MIL-PRF-19500/684
AMENDMENT 2
5 August 2002
SUPERSEDING
AMENDMENT 1
7 June 2001

PERFORMANCE SPECIFICATION

SEMICONDUCTOR DEVICE, TRANSISTOR, FIELD EFFECT, SILICON, N-CHANNEL,
RADIATION HARDENED (TOTAL DOSE AND SINGLE EVENT EFFECTS)
TYPES 2N7472U2, 2N7473U2 AND 2N7474U2
JANTXVR AND JANSR

FIGURE 3. Safe operating area graph."

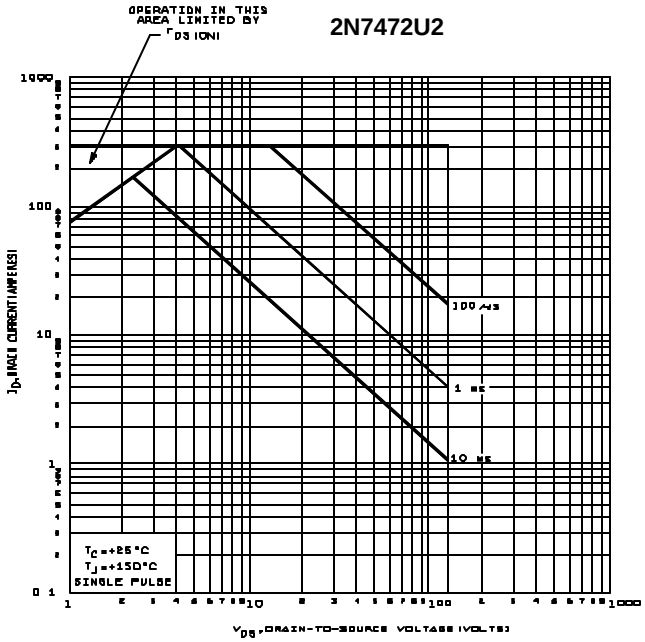
FIGURE 3, delete and substitute:

FIGURE 4. Safe operating area graph."

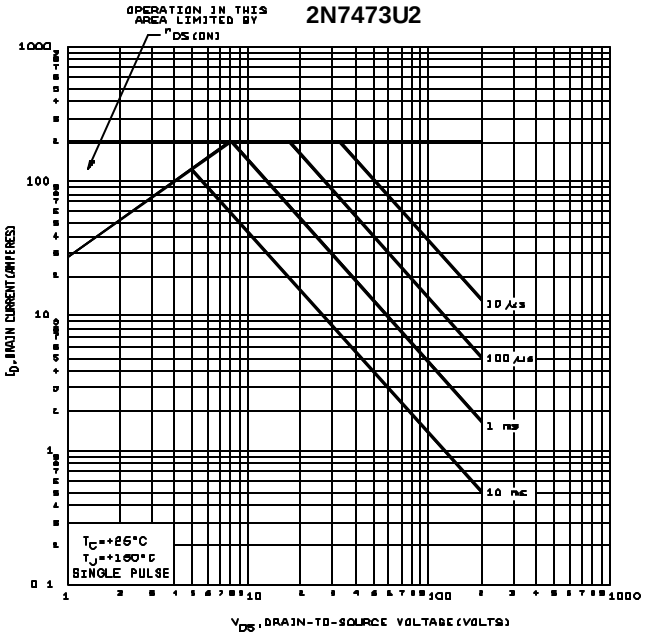
FIGURE 4, delete and substitute:

FIGURE 5. Safe operating area graph."

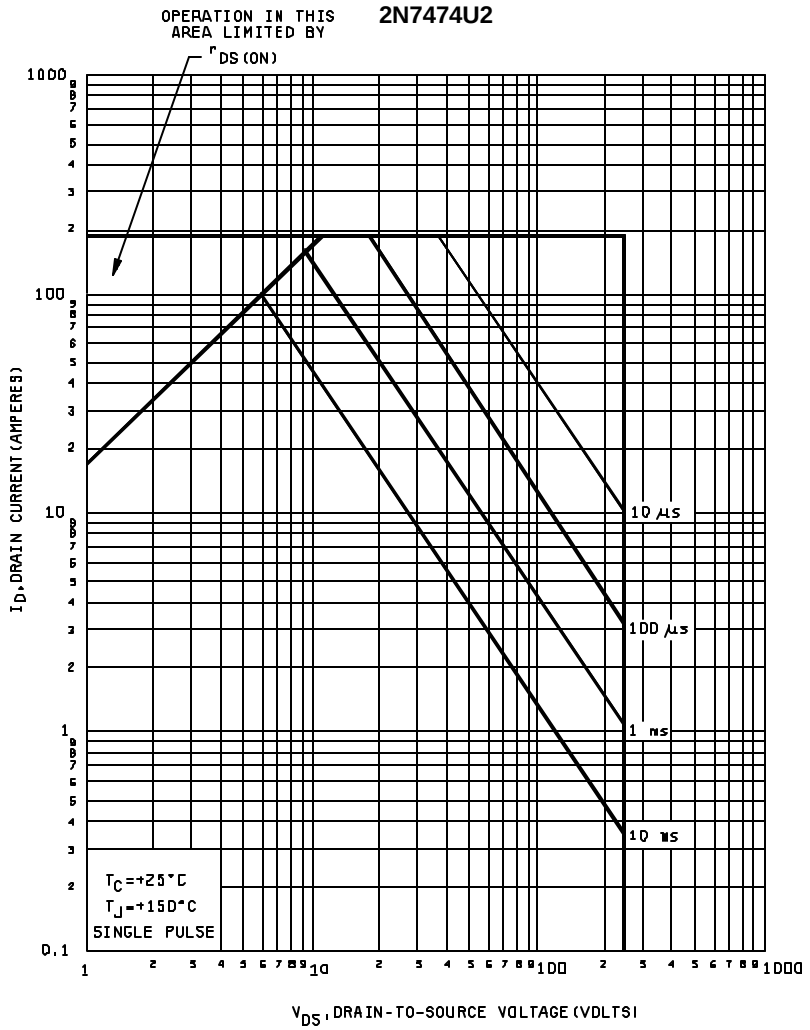
FIGURE 5, delete and substitute:
